**CITY OF DULUTH**  
Planning Division

## STAFF REPORT

<b>File Number</b>	PL 13-165	<b>Contact</b>	Jenn Reed Moses, jmoses@duluthmn.gov
<b>Application Type</b>	Planning Review	<b>Planning Commission Date</b>	January 14, 2014
<b>Deadline for Action</b>	<b>Application Date</b>	December 13, 2013	<b>60 Days</b> February 11, 2014
	<b>Date Extension Letter Mailed</b>	December 20, 2013	<b>120 Days</b> April 12, 2014
<b>Location of Subject</b>	609 W Central Entrance		
<b>Applicant</b>	Members Cooperative Credit Union	<b>Contact</b>	218-625-8511, heikt@membersccu.org
<b>Agent</b>	George Janssen	<b>Contact</b>	gjanssen@marketpointecre.com
<b>Legal Description</b>	010-3182-00010		
<b>Site Visit Date</b>	N/A	<b>Sign Notice Date</b>	January 6, 2013
<b>Neighbor Letter Date</b>	December 31, 2013	<b>Number of Letters Sent</b>	11

The applicant is proposing a new 4,400 square foot credit union with three drive-through lanes.

revision/issue  
**SITE PLAN**  
 sheet number  
**1**

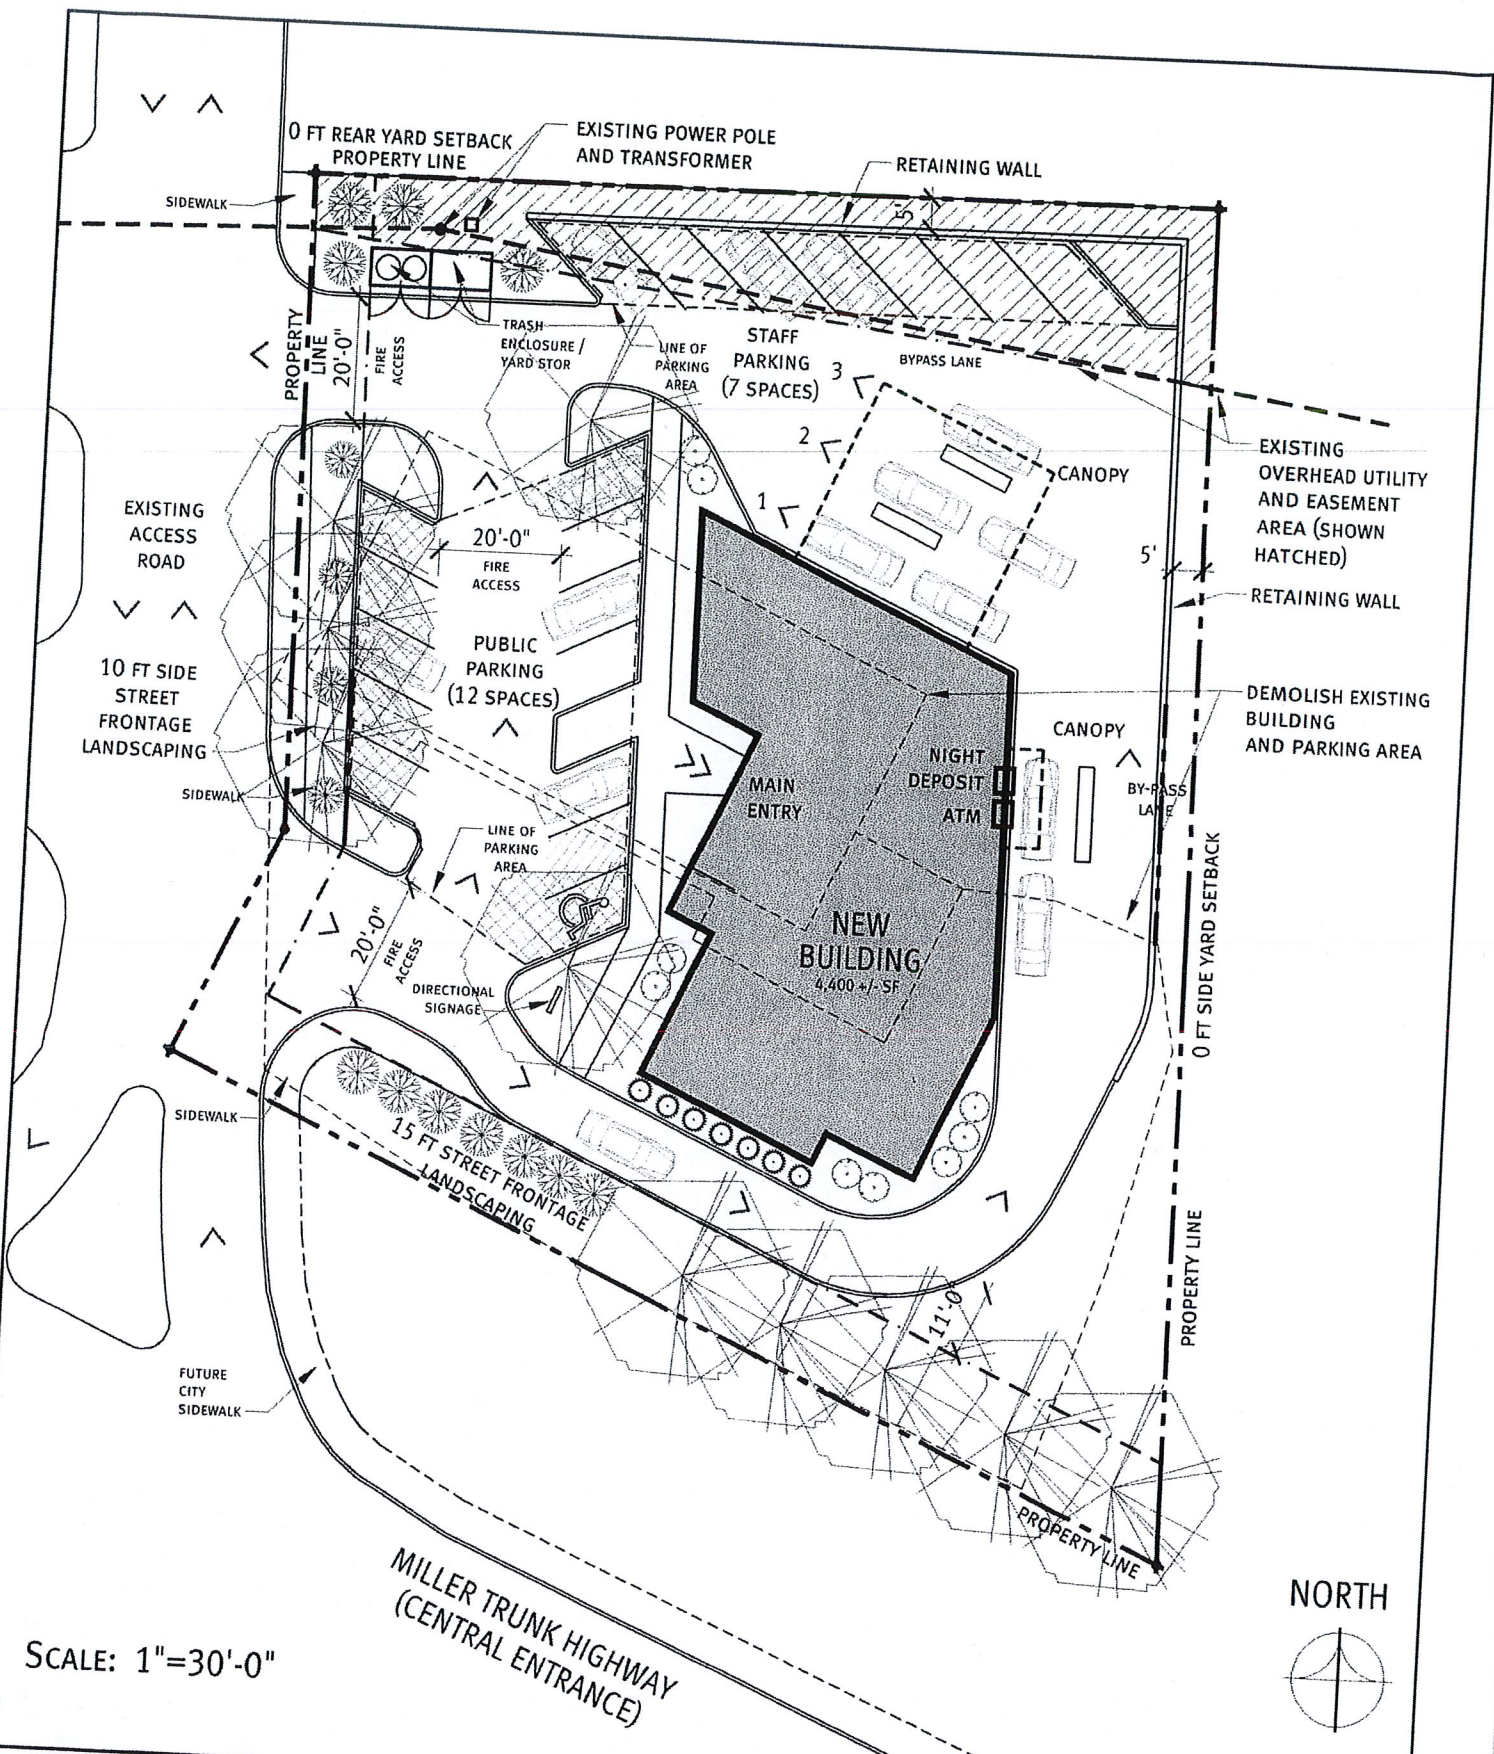
- 1.) 50-15.3 - The proposed structure meets setbacks and height limit. Building will be one story with an approximate height of 20 feet.
- 2.) 50-18.1 - The proposed structure is within a shoreland of Coffee Creek, but located outside the building setbacks. Coffee Creek is a trout stream and, per City Engineering, project is adding new impervious surface. Project will need to include stormwater controls for rate, temperature, and water quality. Applicant is currently working with City Engineering on design of the stormwater system.

- 3.) 50-23 - Site plan includes an on-site sidewalk that will connect to a future City sidewalk along Central Entrance, and sidewalks along the property line with the existing access road to Cub Foods. To ensure safe pedestrian access, sidewalk from Central Entrance should include striping where it crosses the drive-through lane. Applicant is encouraged to also construct sidewalk along Central Entrance, in order to provide further pedestrian connectivity.

- 4.) 50-24 - Site plan shows 19 parking spaces, two spaces over the maximum limit. Applicant has applied for a variance to the maximum parking requirement. Temporary snow storage will be provided at the staff parking stalls with immediate snow removal off site.

- 5.) 50-25 - Site plan shows areas for street frontage landscaping. Number and type of plants will need to be confirmed with a landscaping plan prior to construction. Due to the small parking lot size, it is exempt from providing interior parking lot landscaping, but must still meet the minimum 30% tree canopy coverage.

- 6.) 50-26 - Trash enclosures are located in the rear of the property and will be screened. Retaining walls are shown along the north and east of the property and will be less than 6 feet high. All screening and walls will need to be verified at the time of building permit application to ensure they meet UDC requirements.

- 9.) 50-31 Exterior Lighting will be designed to meet UDC requirements. Applicant will need to have an approved lighting plan and photometric plan prior to receiving a building permit.

- 1.) The project be limited to, constructed, and maintained according to the Site Plan dated December 12, 2013.
- 2.) Sidewalk from Central Entrance include striping where it crosses the drive-through lane.
- 3.) Applicant comply with UDC parking maximums, or apply for and receive a variance to those requirements.
- 4.) A complete landscaping plan meeting UDC requirements is approved prior to receiving a building permit.
- 5.) Screening and lighting requirements be verified prior to receiving a building permit.
- 6.) Any alterations to the approved plans that do not alter major elements of the plan may be approved by the Land Use Supervisor without further Planning Commission; however, no such administrative approval shall constitute a variance from the provisions of Chapter 50.
